INFORMATION BULLETIN NO. 46A

TO: ALL OWNERS, OPERATORS, AND REBUILDERS OF J. H. FLETCHER & CO. MODEL DDO AND RRII ROOF BOLTING EQUIPMENT

SUBJ: CLEVIS PIN RETROFIT PROGRAM FOR DRILLING CONTROLS – VALVES ONLY

ILLUSTRATION NO. 1

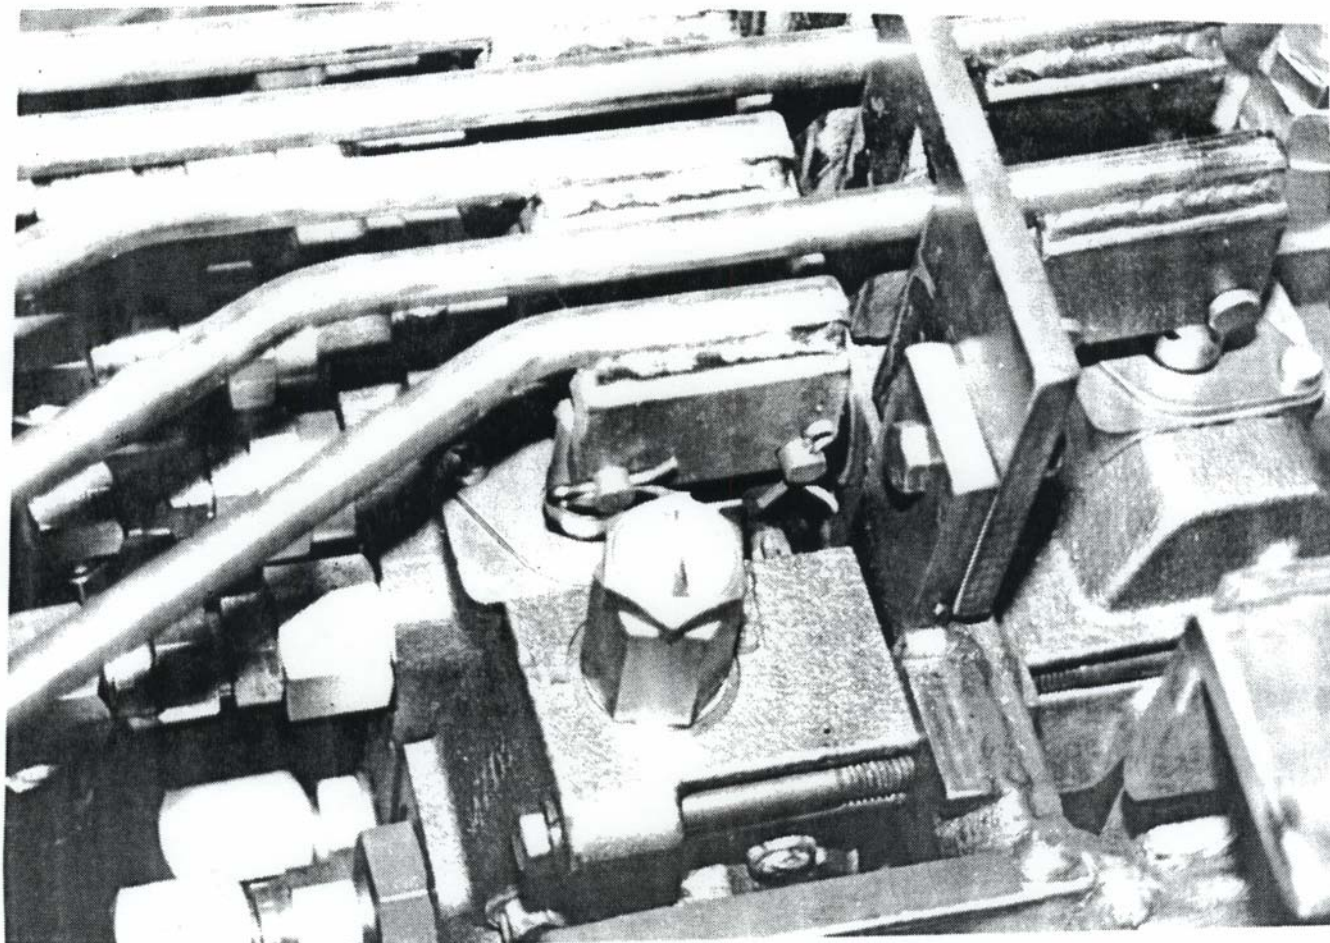
All J. H. Fletcher & Co. Model DDO and RRII roof bolters manufactured between January 1974 through May 1993, incorporated a clevis pin and a cotter key to hold the handle onto the valve bank (See Illustration No. 1). This system of connecting the valve bank handles with the valve section stem has been used by J. H. Fletcher & Co. for many years without problems.

Recently, J. H. Fletcher & Co. discovered that the clevis pin arrangement may cause the rear valve bank handles to stick on cotter pins in the front valve bank of the drilling controls if specific mechanical conditions exist. The cotter key must extend vertically from the clevis pin and the handle must be bent to interfere with this cotter key. In order to reduce this potential risk from the use of this clevis pin arrangement, we are now undertaking a retrofit of the front pins on the forward valve bank (See Illustration No. 2).
